INVESTIGATION OF THE SEISMIC RISK OF INDUSTRIAL PIPE RACK – PIPING SYSTEMS ACCOUNTING FOR SOIL-STRUCTURE INTERACTION

Version 1: [Draft Paper](#)

Reviewer Comments

Figure 1. The three-floor petrochemical plant steel pipe rack in CS #1 (a) the overall, (b) the critical components of the piping system, and (c) piping system layout.

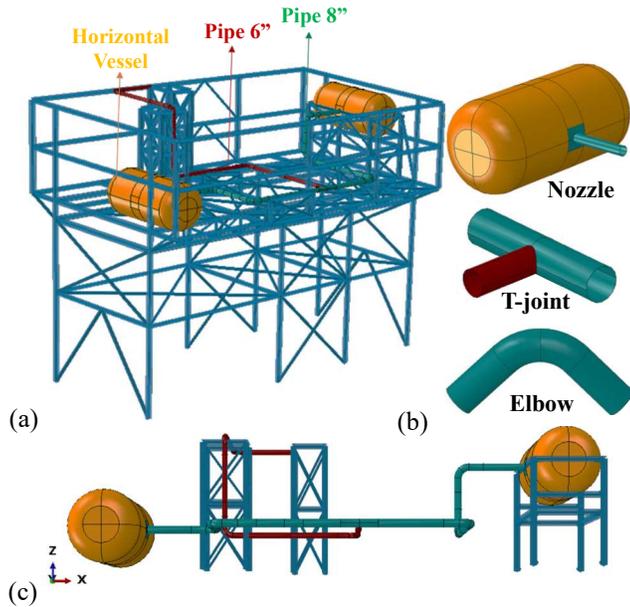
- The rack is 12 m high (4 m each floor) and is outfitted with a piping system (Figure 1b), which runs along the length and the height of the third floor. **Comment: Figure 1b shows tank and pipe fittings or elements but not system. THE CAPTURED HAS CHANGED TO FIGURE 1a.**

- pipes cannot be considered rigidly supported on the rack (Figure 3c) **Comment: Figure 3 must be Figure 1c. FIXED.**

Figure 2. The capacity curves for (a) X-direction and (b) Y-direction and two analyses methods, namely pushover and time-history or IDA

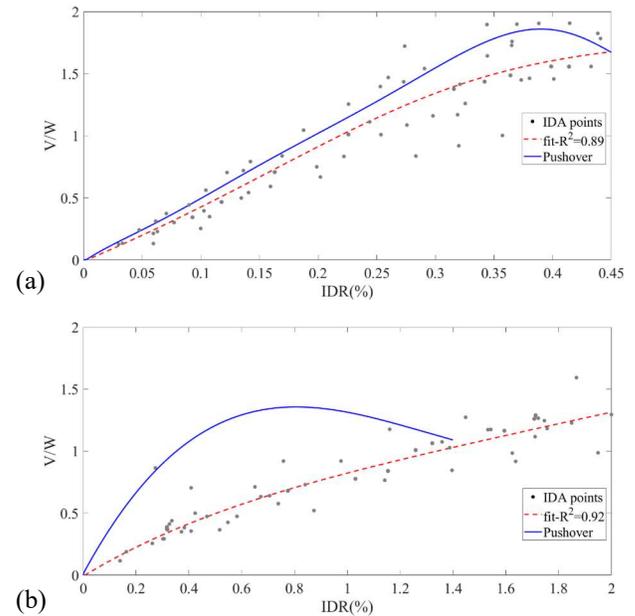
- Figure 2 **Comment: Font size in Figure 2 is so small that reader cannot recognize. THE CAPTURES ON THE GRAPH HAVE BEEN REMOVED.**

Figure 4. (a) The LNG terminal plant and pipe rack in CS #2; (a) The LNG terminal layout ([35]), and (b) the RC pipe rack modeled by Seismostruct code.

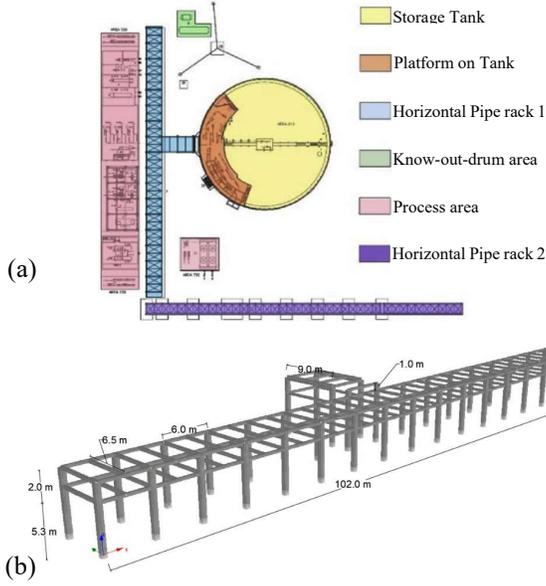
- The modular or precast RC rack that is examined in this section refers to a Refrigerated Liquefied Gas (RLG) terminal. It is a long rack (total length 102 m) outfitted with numerous stainless-steel pipelines of different diameter and internal pressure that transfer gas from an adjacent tank to other process units (Figure 7a&b). **Comment: It might be Figure 3a&b. The caption “Figure 3a” should be “Figure 3”. FIXED.**

The writing of the caption in Figures 1 and 4 is bad. Rewrite them in accordance with the samples and template of ASME and ASME guideline. **THE CAPTIONS HAVE BEEN MODIFIED IN ALL FIGURES BY USING PARENTHESES () AS THE ASME GUIDELINES PROPOSE (SAMPLE PVP2019 PDF FORMAT).**

This reviewer does not agree with your proposing writing style of the caption in Figures 1 and 4. This reviewer thinks that all figure captions need main titles which represent the overall of figures. Please see the sample PVP2019 pdf format on the web. The caption of figure 8 of the sample is good example. For example, this reviewer recommends the following figure caption; Figure 1. The three-floor petrochemical plant steel pipe rack in case study #1; (a) the overall, (b) the critical components of the piping system, and (c) piping system layout. Figure 4. The LNG terminal plant and pipe rack in case study #2; (a) The LNG terminal layout [35], and (b) the RC pipe rack modeled by Seismostruct code. **THE CAPTIONS HAVE BEEN MODIFIED ACCORDING TO YOUR SUGGESTIONS. ALL THE FIGURES HAVE NOW THE SAME FORMAT.**
